Access Compliance Report Public Rights-of-Way (RR Crossings)

Intersection ID: 51491	Main Street: N_TRYON_ST	Location: N/A
ADA ID: F6D034B5C947	Overall Compliance: No	Severity Score: 0.0
Codes/Mitigation Info/Possible Solution		Field Measurements/Component Compliance

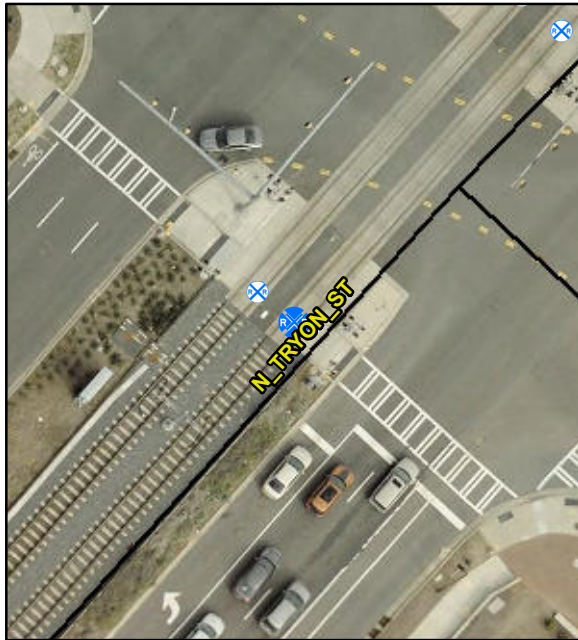
**Install Detectable Warning System.
Remove & Replace Walking Surface
Adjacent to Rail.**

R208.1, R302.7.4

Compliance	Description	Data
No	DWS Provided?	No
N/A	DWS Contrast?	N/A
N/A	DWS Width (in)	N/A
N/A	DWS Length (in)	N/A
N/A	DWS Offset (in)	185.0
Yes	Pedestrian Gate?	Yes
N/A	DWS Outside Gate?	Yes
N/A	Rail Type?	LightRail
No	Flangeway Gap (in)	3.0
Yes	Sidewalk Width (in)	120.0
